January 19, 2024

**LINCOLN PUBLIC SCHOOLS
ARTS & HUMANITIES FOCUS PROGRAM – ENHANCEMENT PROJECT
LINCOLN, NEBRASKA**

ADDENDUM #1

1 REFLECTED CEILING PLAN OVERALL PLAN
A3.0 3/32" = 1'-0"

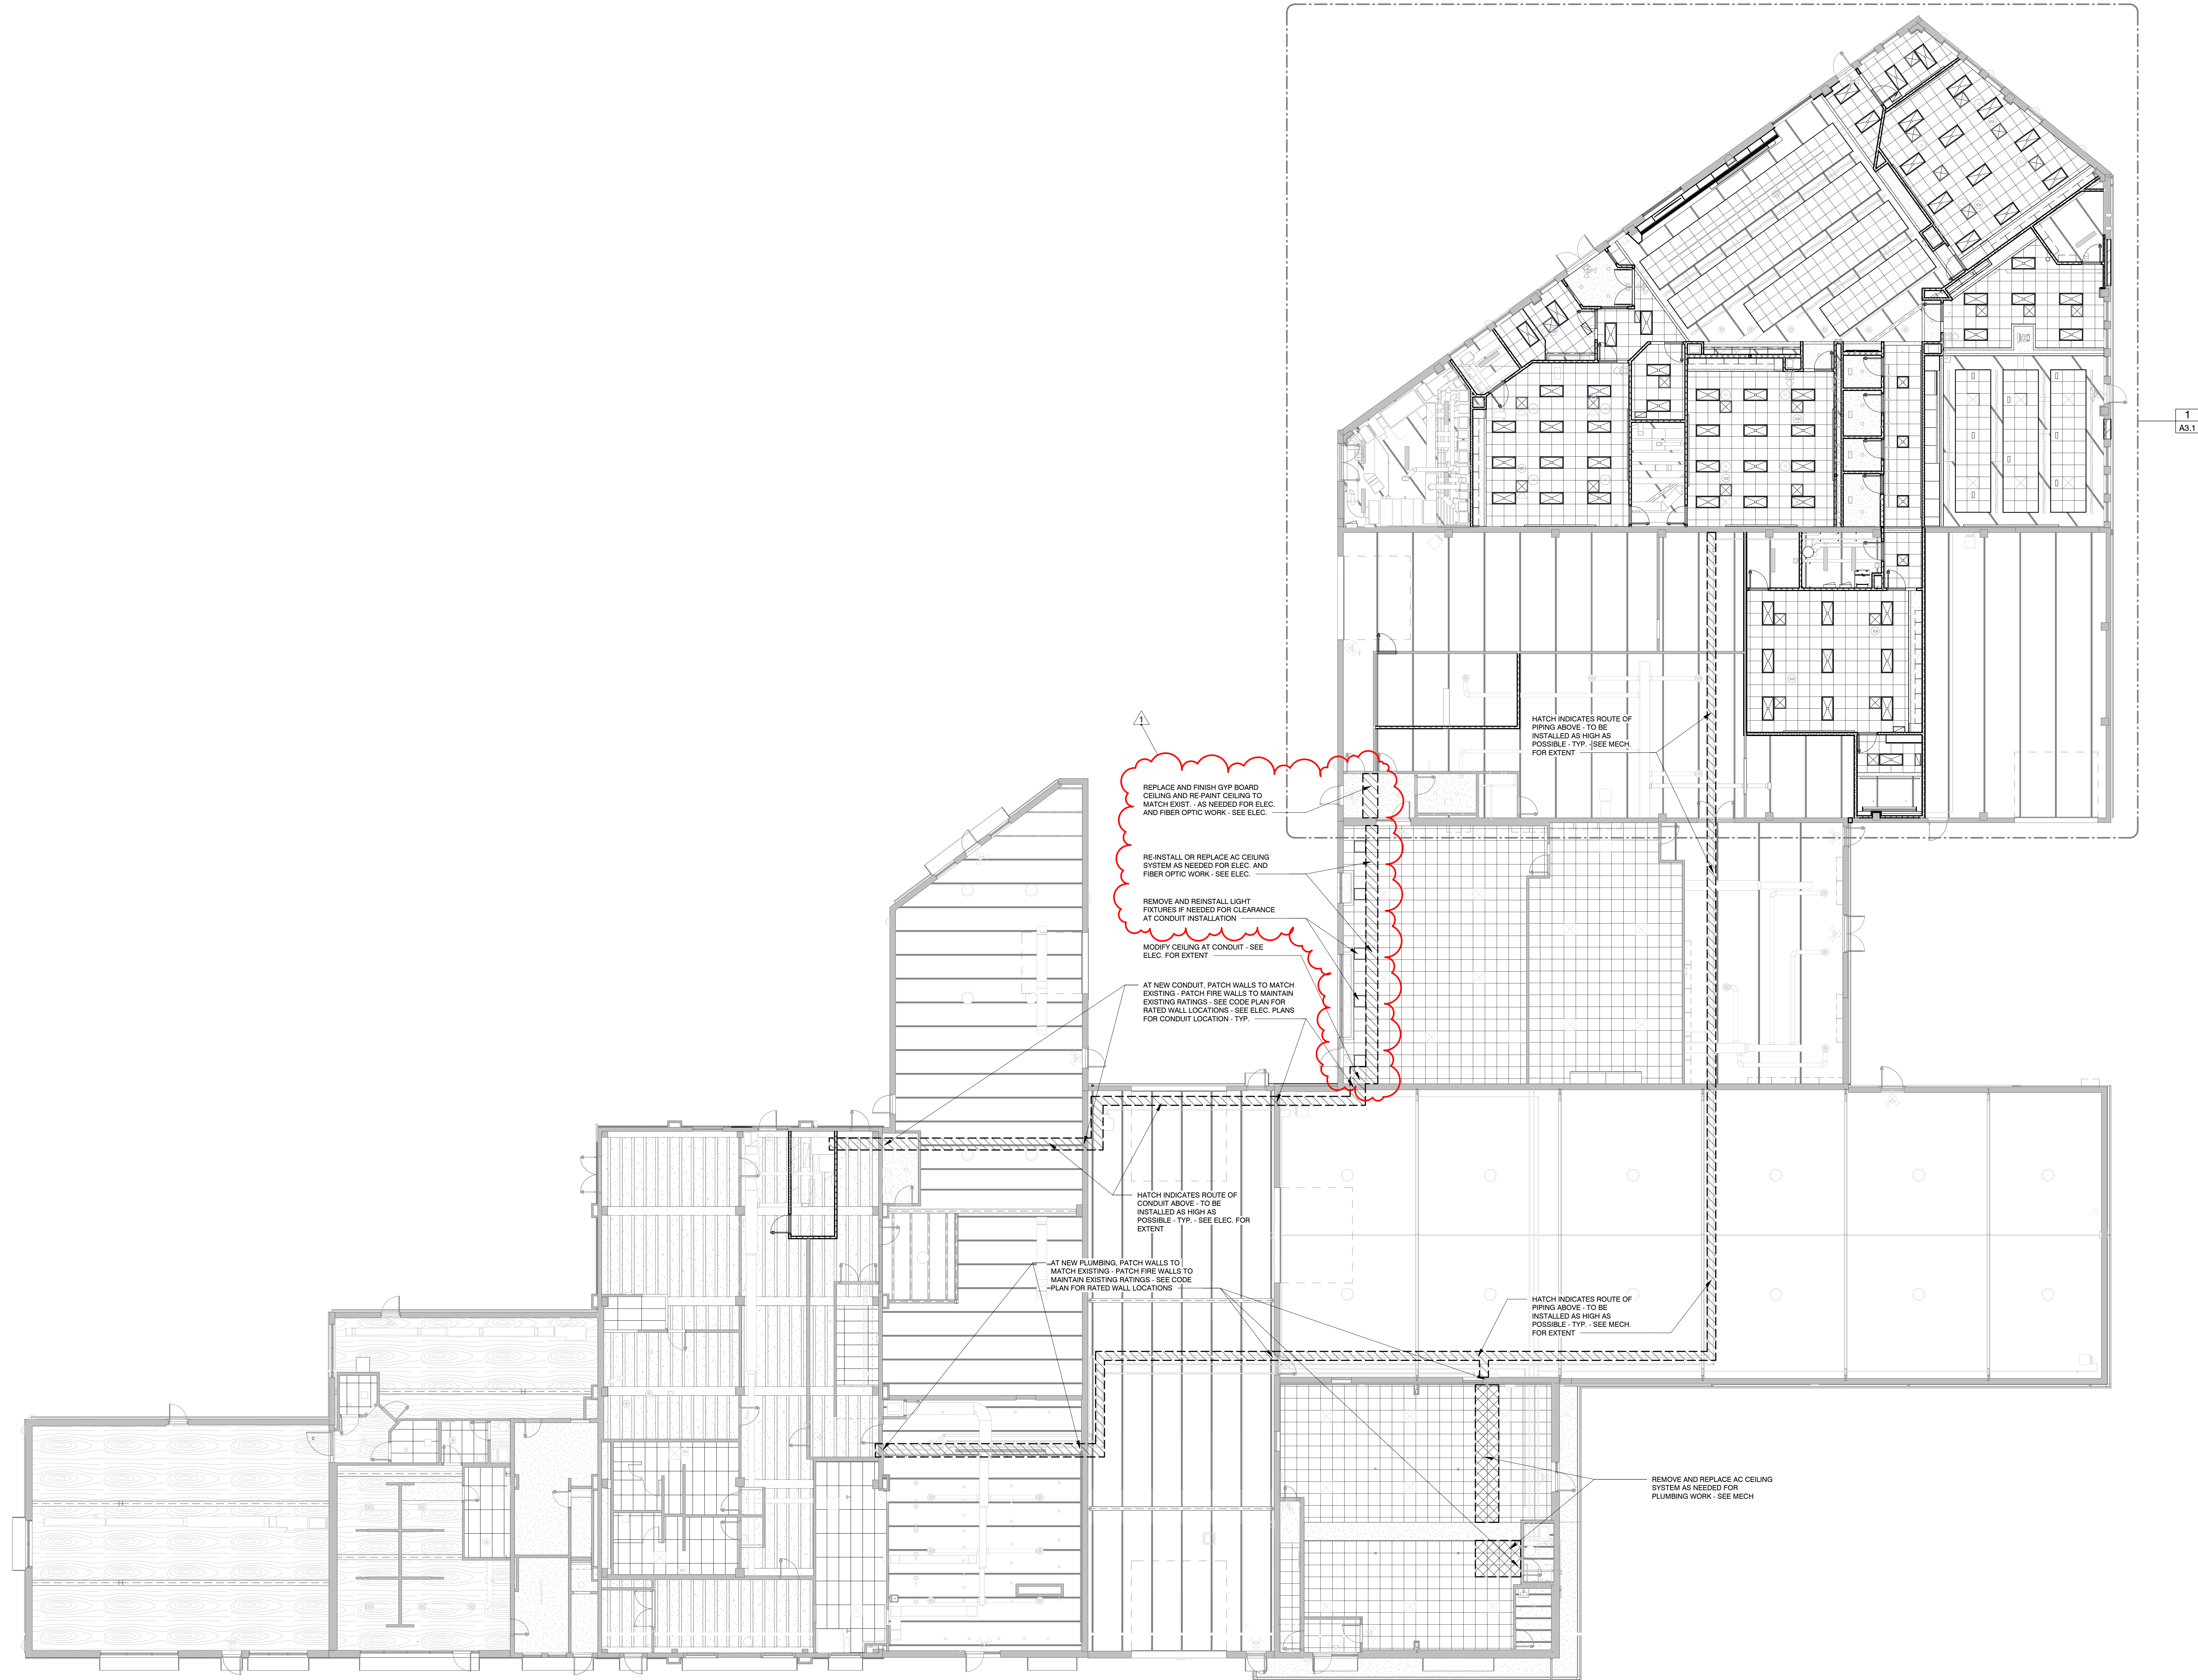
Item No. 1-9:**Sheet A3.0 – RCP Overall Plan**

- A. At 'RCP Overall Plan – Detail 1' – At OT/PT Office 100, remove and reinstall lights and remove and reinstall or replace ceiling pads and grid as needed to install electrical and fiber conduit. See Elec for extent and location.
- B. At Vest. 180, replace, finish and paint gyp board ceiling to match existing as needed to install electrical and fiber conduit. See Elec for extent and location of conduit.

1 REFLECTED CEILING PLAN

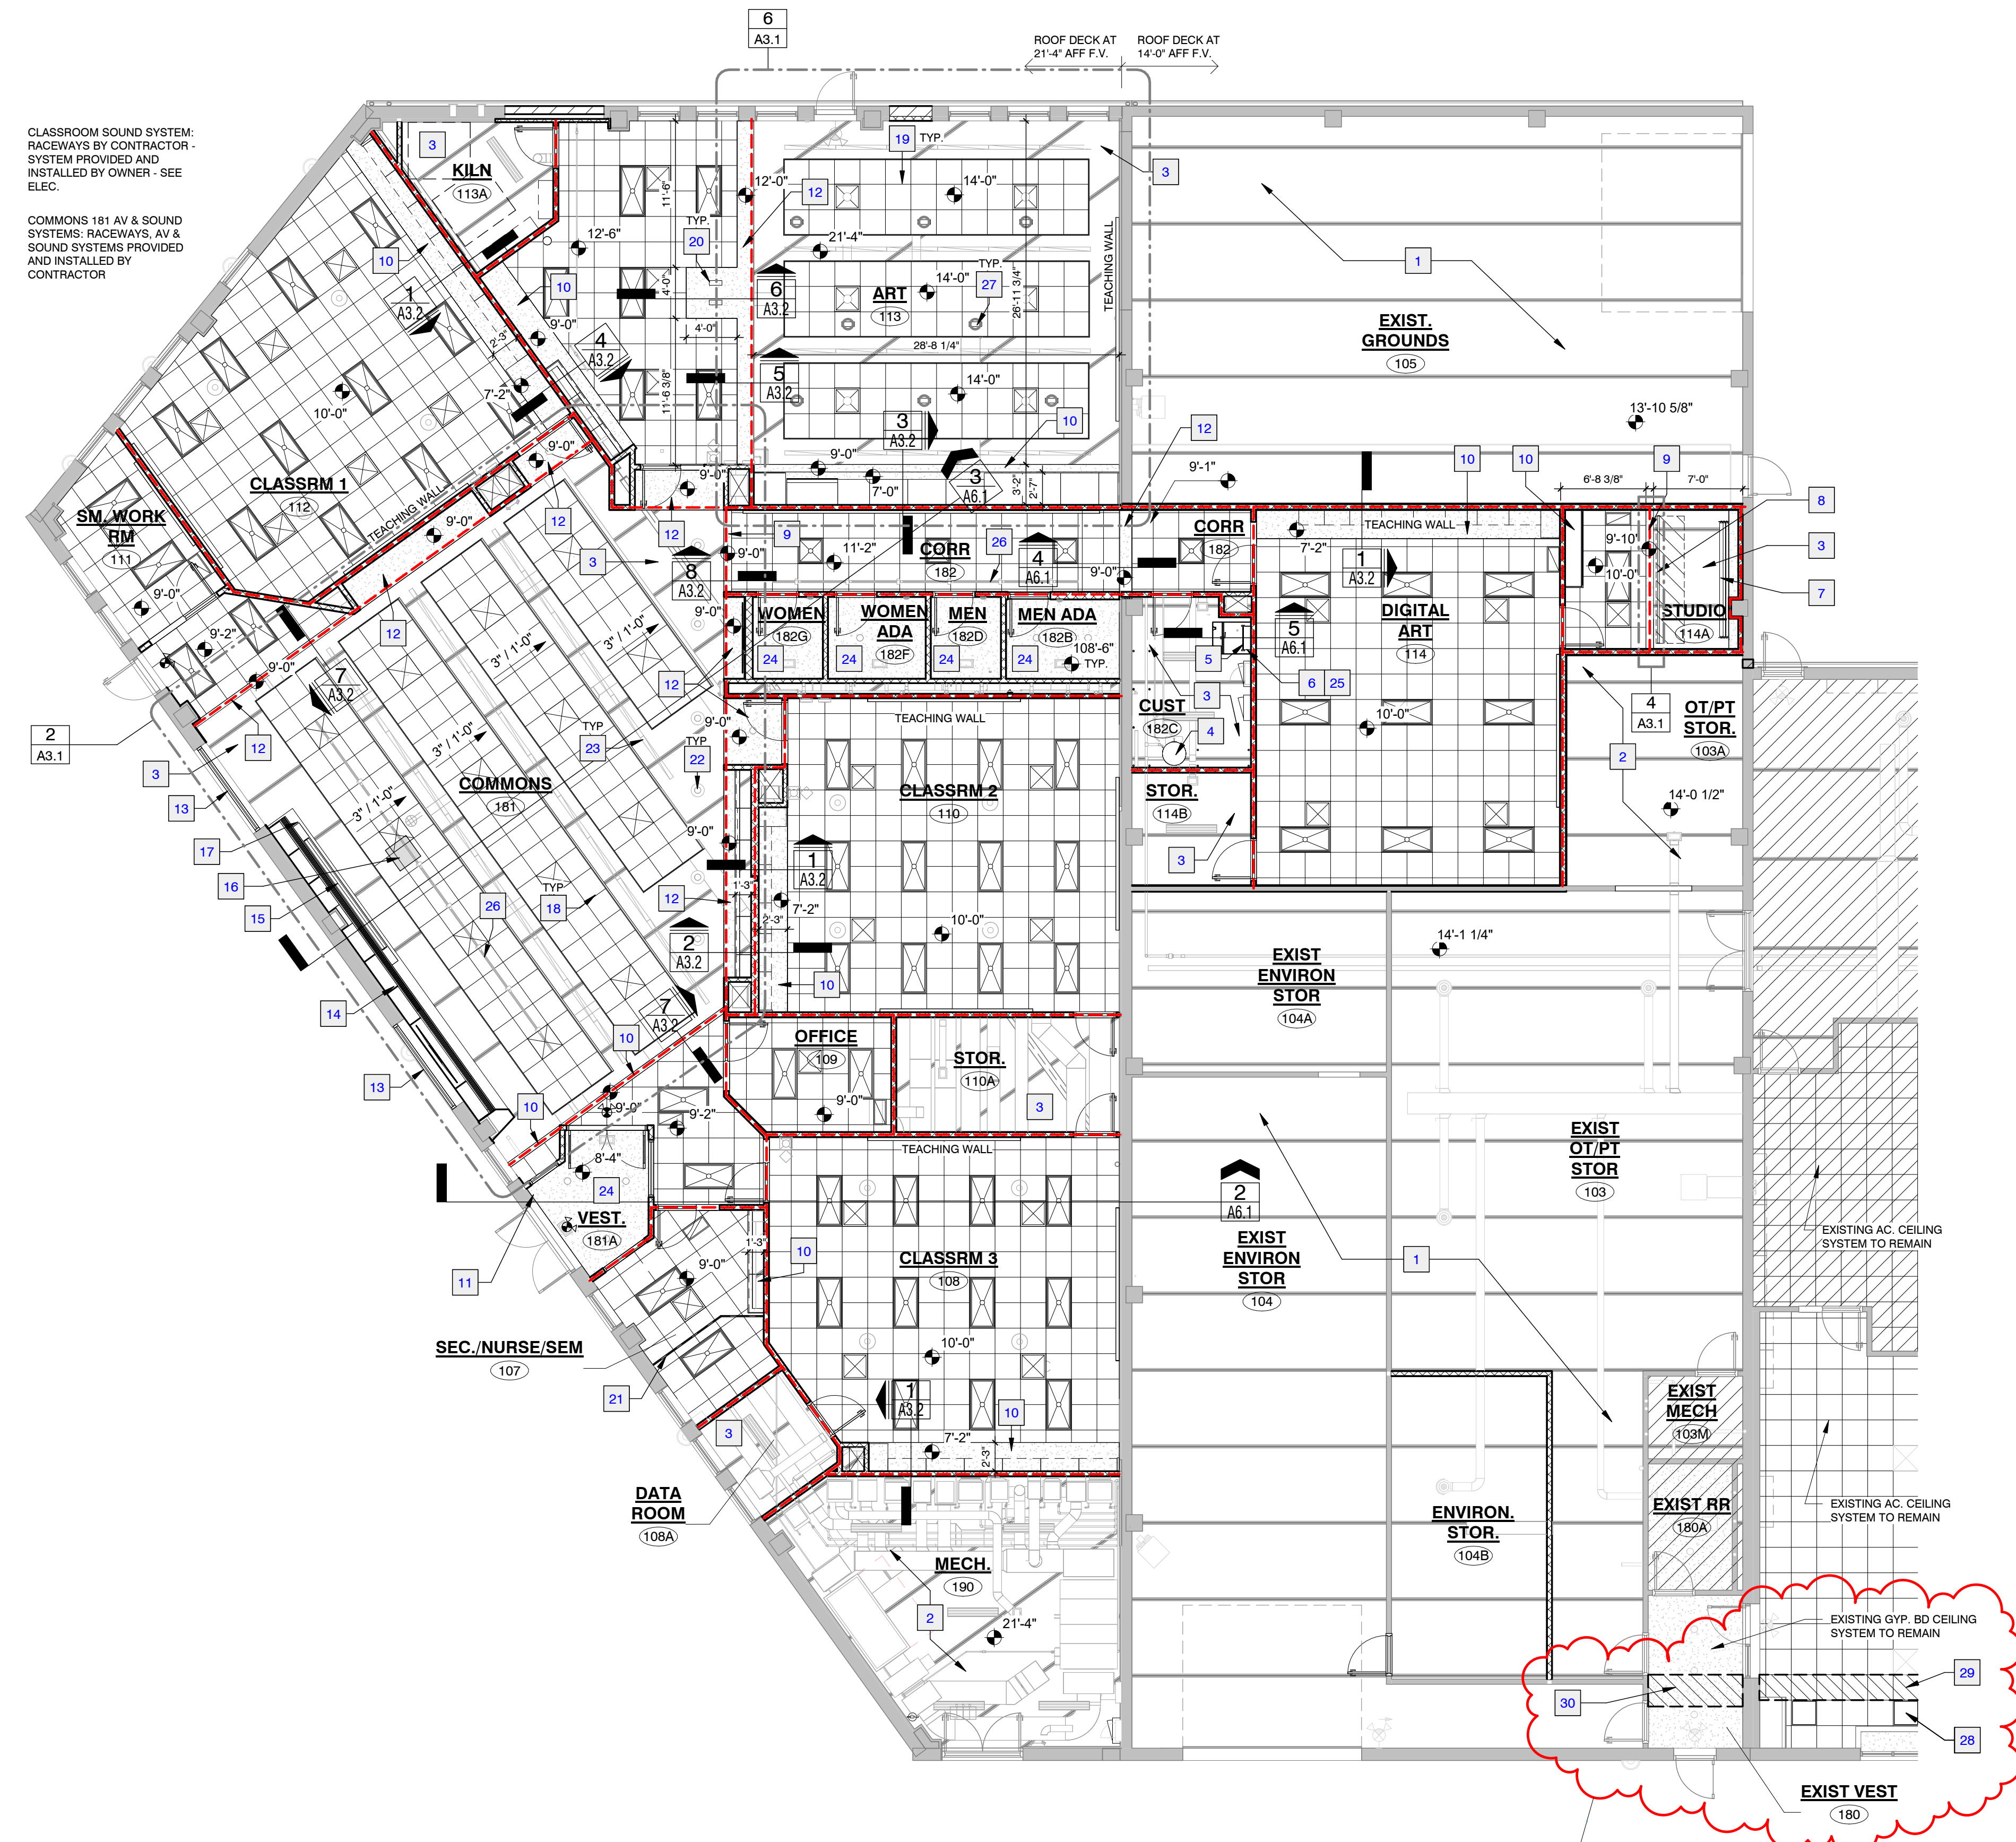
Item No. 1-10:**Sheet A3.1 – RCP Plans**

- A. At 'Reflected Ceiling Plan – Detail 1' – At OT/PT Office 100, remove and reinstall lights and remove and reinstall or replace ceiling pads and grid as needed to install electrical and fiber conduit. See Elec and Sheet A3.0 for extent and location.
- B. At 'Reflected Ceiling Plan – Detail 1' – At Vest. 180, replace, finish and paint gyp board ceiling as needed to install electrical and fiber conduit. See Elec and Sheet A3.0 for extent and location of conduit.

8 PIPE BOLLARD DETAIL

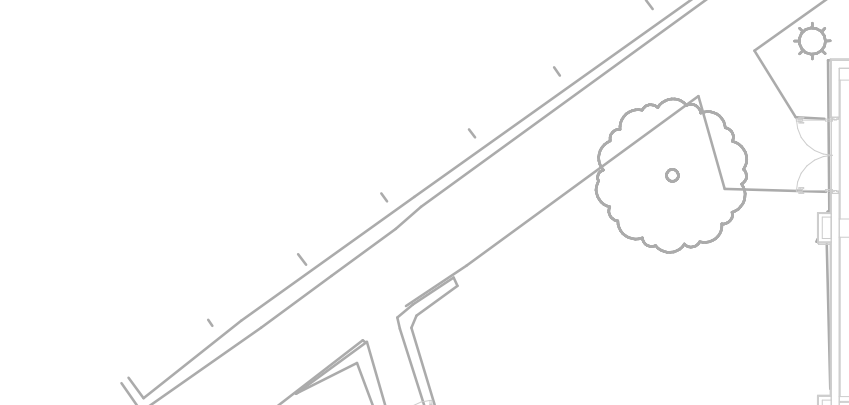
- A. OVERALL FIRE PROTECTION PLAN
 - Studio 114A; Added Keynote #9 to paint exposed piping in room
 - Art 113 & Studio 114A; Revised Sprinkler Head hatch pattern in rooms to distinguish between exposed ceiling and lay-in ceiling areas of room. Refer to A3.1 for more information on ceiling types.
- B. FIRE SPRINKLER PIPE MATERIAL AND INSULATION SCHEDULE
 - Pipe Material and Insulation General Notes; Remove first bullet point "Domestic Water Insulation Requirements" and sub-notes A, B & C.
- C. D6 – FIRE DEPARTMENT CONNECTION DETAIL
 - Remove manhole and drum drip drain. FDC piping to be sloped back towards ball drip drain located at fire service entrance in basement.
- D. D8 – PIPE BOLLARD DETAIL
 - Bollard to galvanized steel.

7 SECTION @ HEAT PUMPS

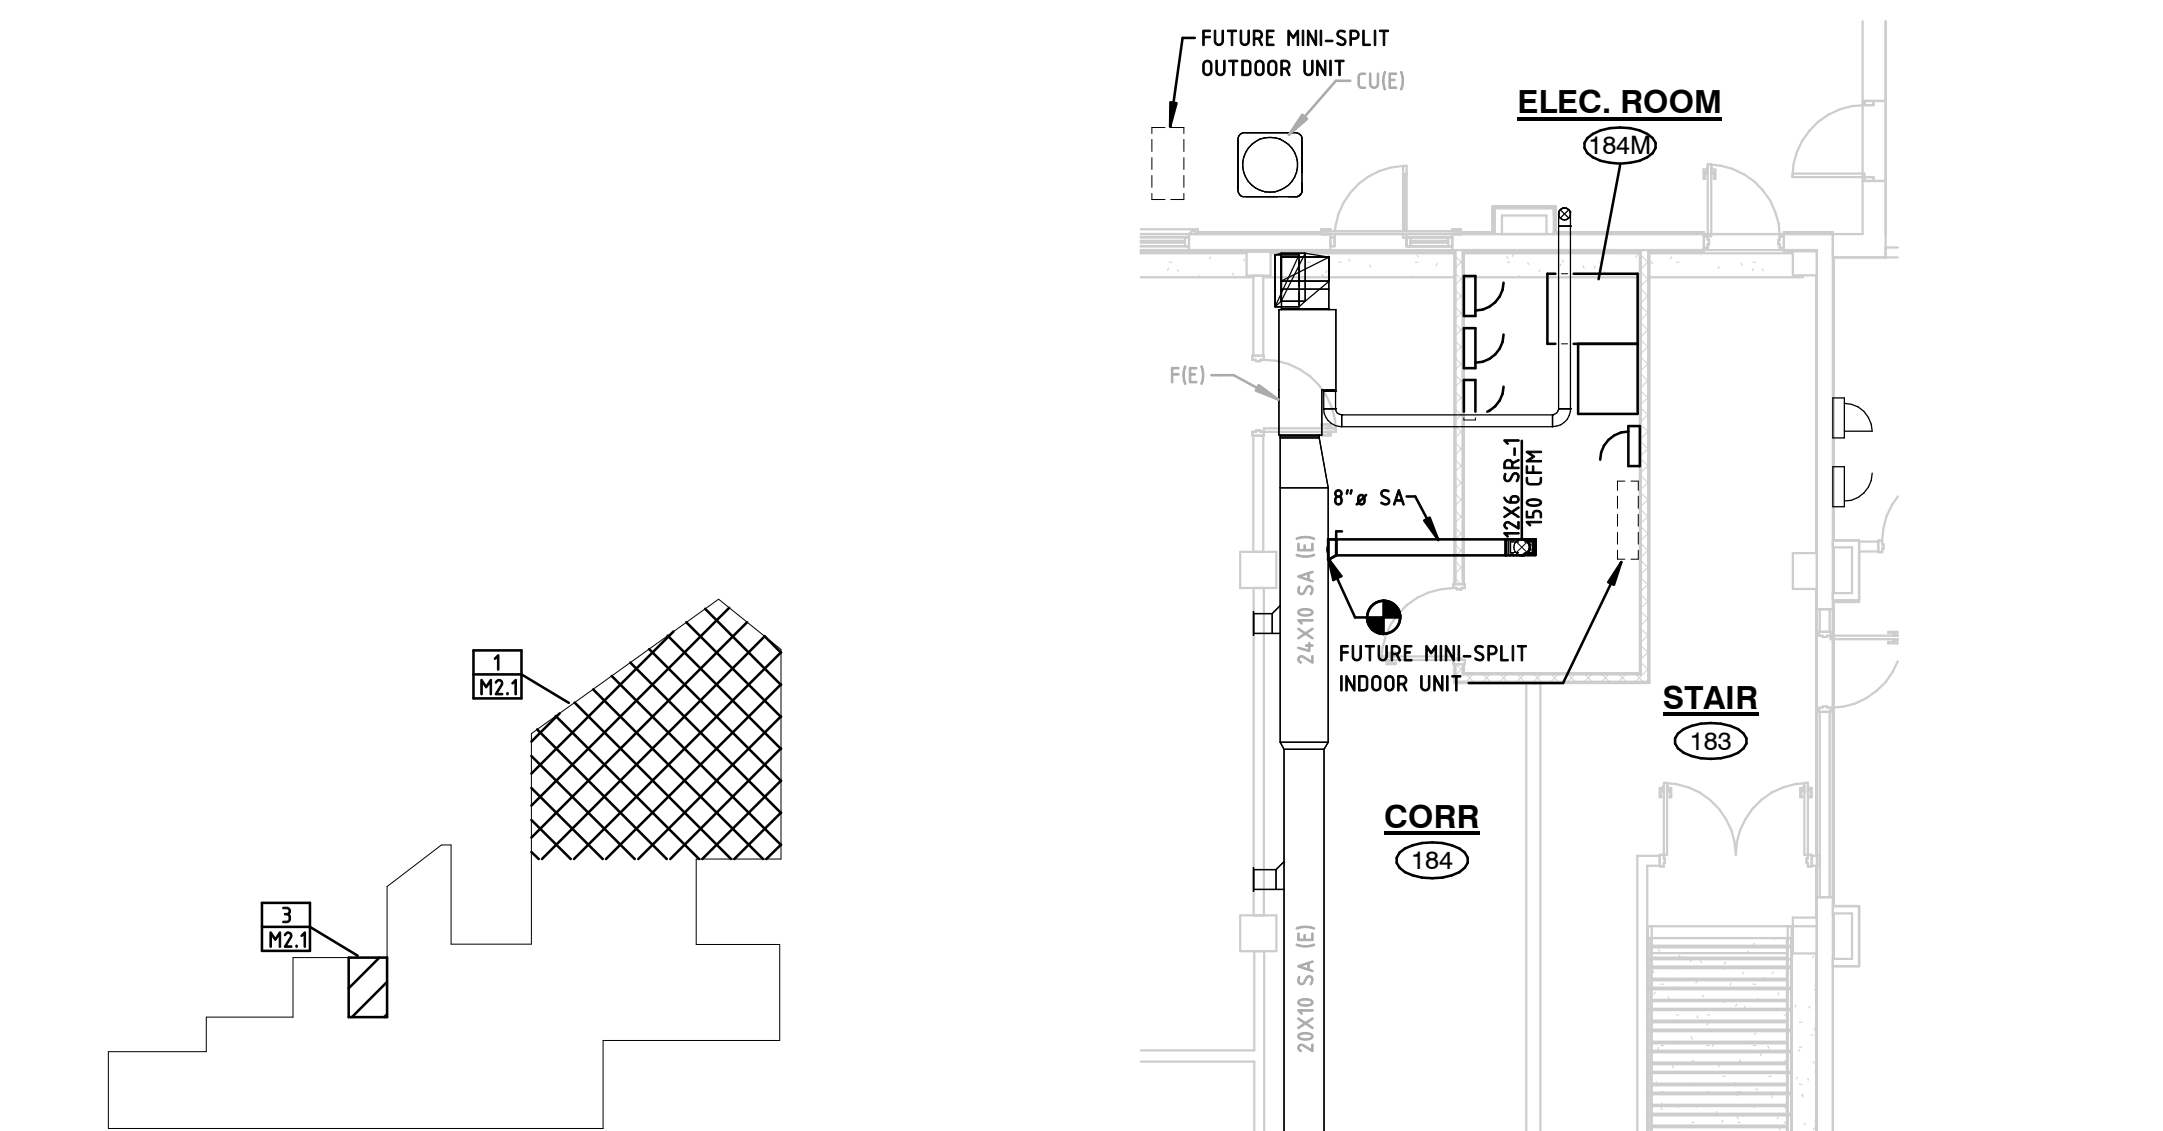
4. M1.2 – MISC. HVAC PLANS AND SECTIONS

- A. D7 – SECTION @ HEAT PUMPS
 - Added minimum dimension (10'-0") between roof edge and Wall Hydrant (WH-1).
 - Added note that Refrigerant piping to be installed min. 10" above roof and 2" above roof edge flashing (whichever is greater).
- B. ROOF PLAN – MECHANICAL
 - Added minimum dimension (10'-0") between roof edge and Wall Hydrant (WH-1).

- Added Keynote #5 to Refrigerant piping - ALL REFRIGERANT PIPING MUST BE INSTALLED 10" ABOVE ROOF AND MIN. 2" ABOVE ROOF EDGE FLASHING - WHICHEVER IS HIGHER. INSTALL STACKED ALONG WALL OR HUNG BELOW EQUIPMENT RACKS AS REQUIRED TO MEET MIN. CLEARANCES.
